ADDENDUM NUMBER 2

POWDER SPRINGS ROAD

SIDEWALK PHASE II

PROJECT NUMBER 13022

KEYSTONE CENTURY WALL® & HALF CENTURY WALL®

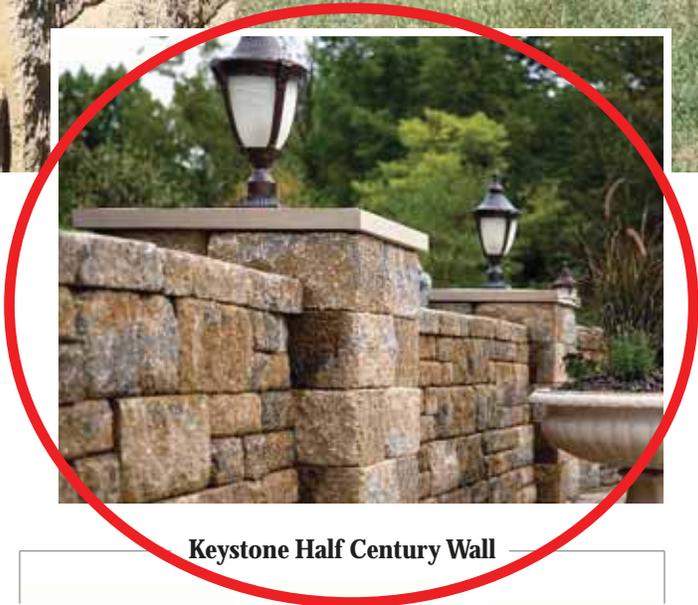
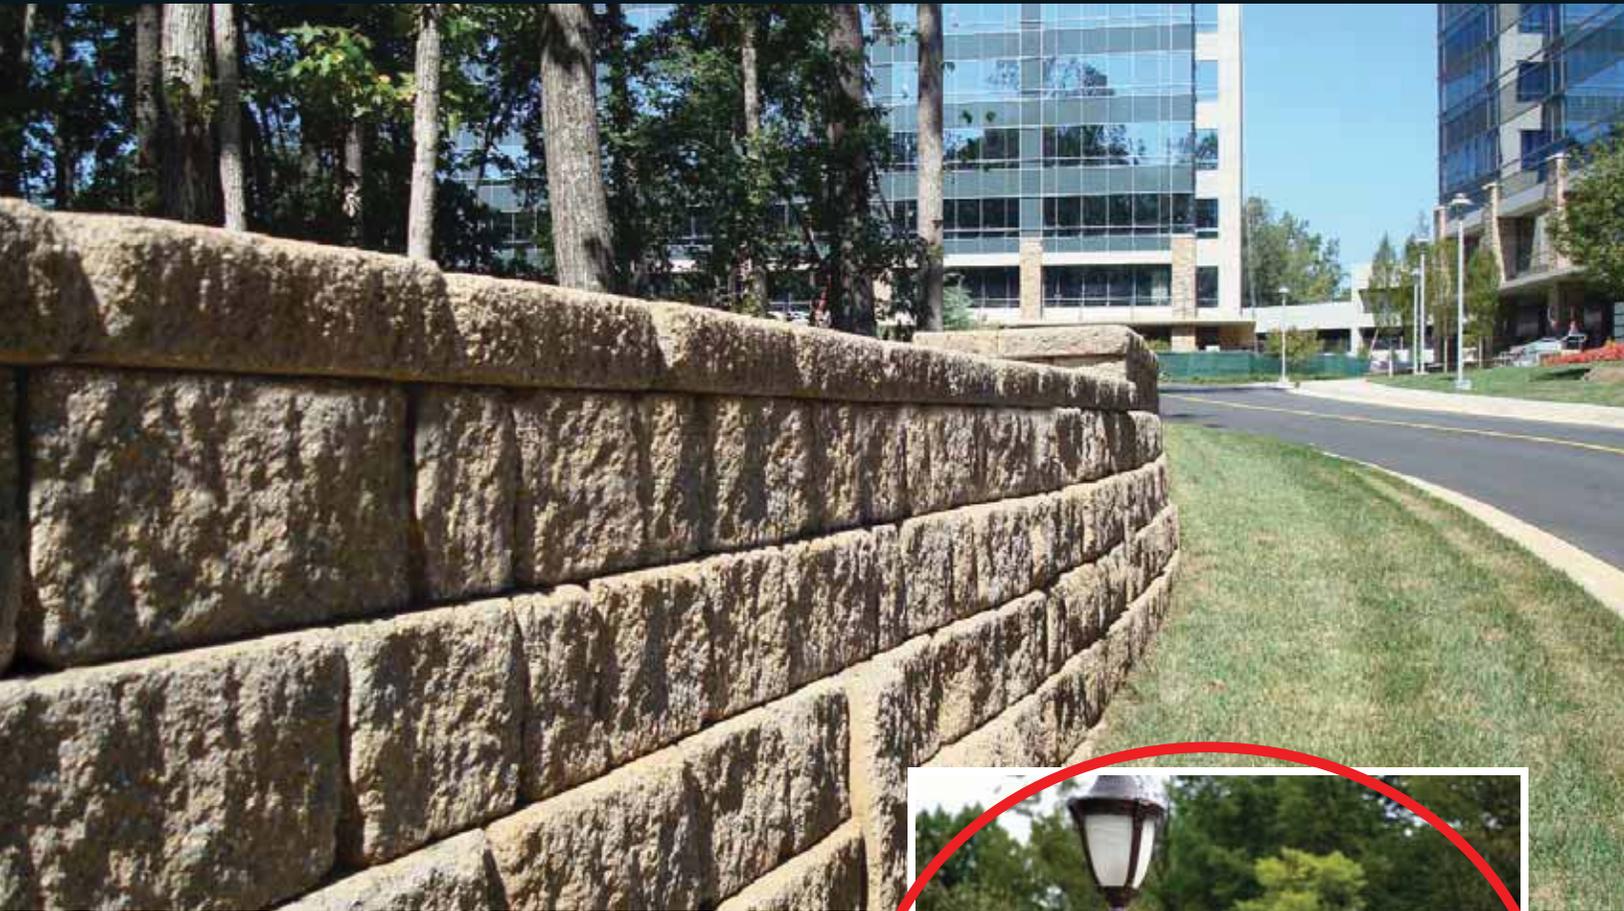
6. Revision to Addendum #1 (number 12). The City would like to use the attached Keystone style detail for the Modular block walls.
